RANDAL PARK ELEM. SCHOOL ACCESS ROAD

Staff Recommendation: Approval of the
Major Plat, subject to conditions in this staff
report.

Updated: October 19, 2012

PROPOSED PLAT

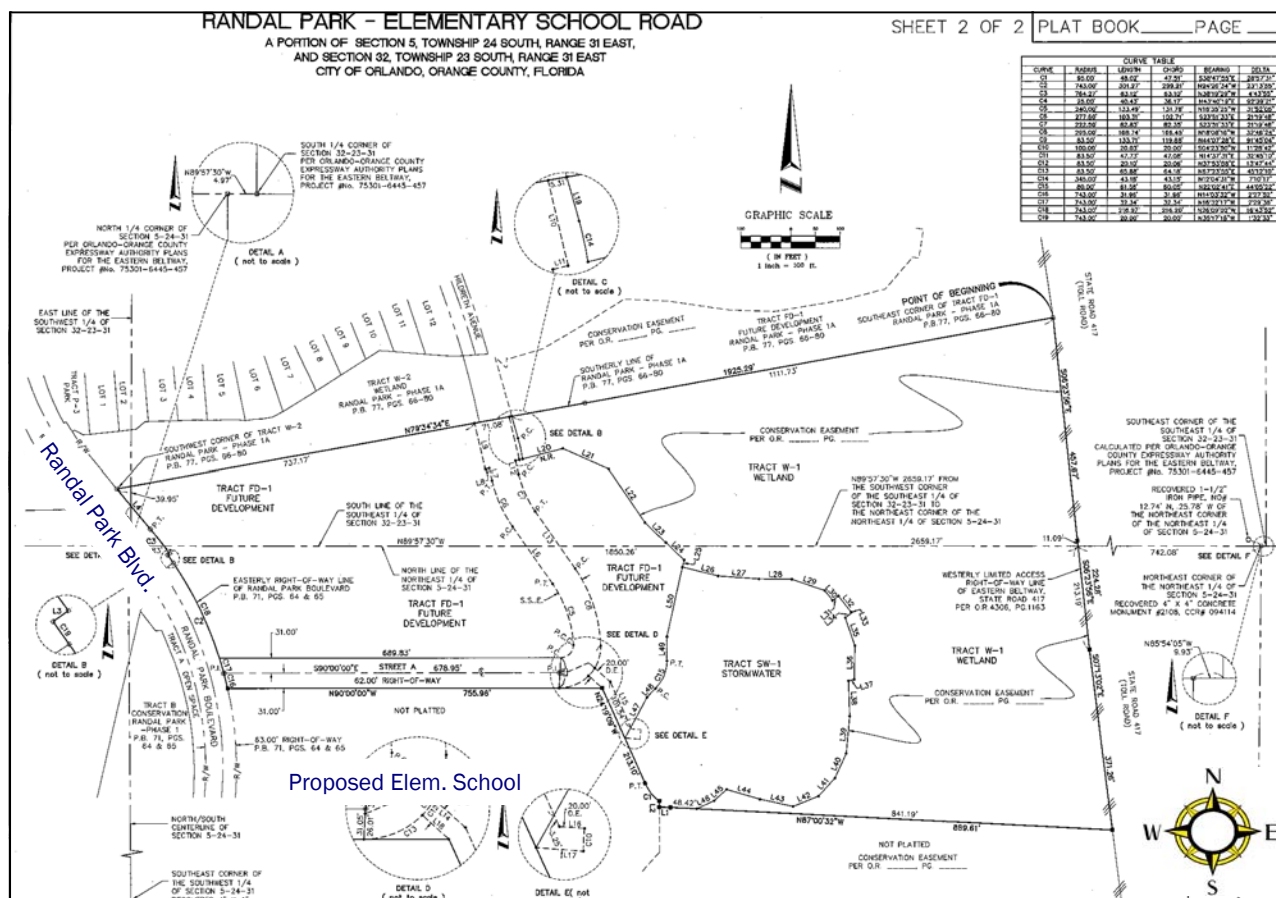
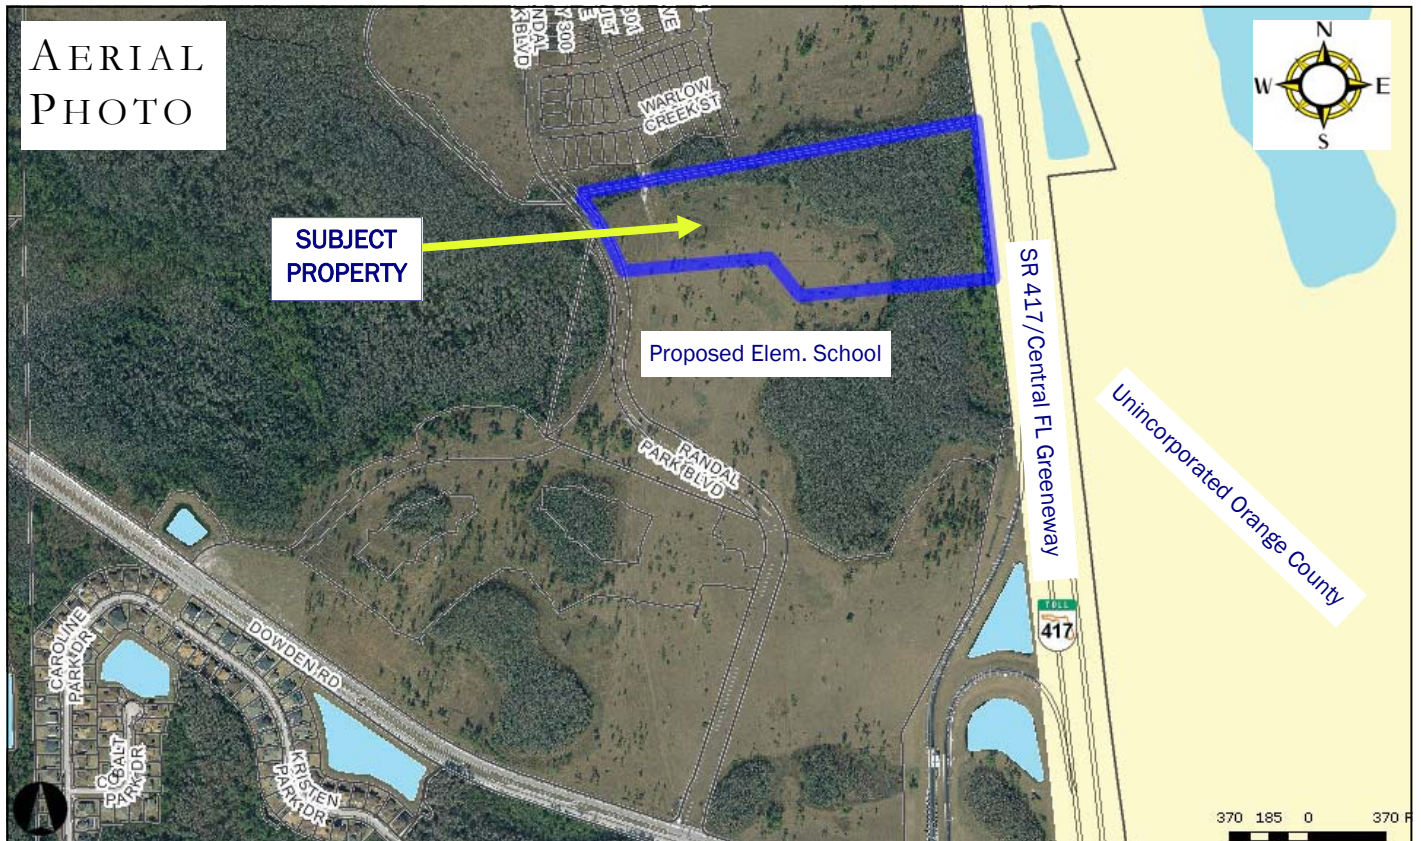
1. SPMP Required for Tract FD-1 - The property owner shall submit a Specific Parcel Master Plan (SPMP) application to the Municipal Planning Board prior to the issuance of a building permit for new construction for the "Future Development" (FD-1) tract.

1. Concurrency Management - The final recorded plat shall contain the following note: "Development on the property depicted on this plat is subject to the requirements of Chapter 59, the Concurrency Management Ordinance of the City of Orlando, which governs the City's ability to issue building permits on this property. Approval of this application shall not be deemed to provide any vested rights, except as to those matters depicted hereon, that are consistent with the requirements of Chapter 177, Florida Statutes, or were required by the City of Orlando as a condition of platting."

1. Sidewalk - Per LDC Section 61.225, a 5 ft. wide concrete sidewalk is required along all dedicated rights-of-way. Any existing sidewalk damaged or broken during construction shall be repaired.

3. Sewer - Verify the capacity of the lift station (currently under construction) that serves the Randal Park residential development and the proposed elementary school. Provide calculations that include wastewater flow generated by the school.

5. Stormwater Management District - The owner/developer is required to design and construct an on-site stormwater system in accordance with the Orlando Urban Storm Water Management Manual and the approved Master Drainage Plan. Approval from South Florida Water Management District is required. The system is to be privately owned and maintained.
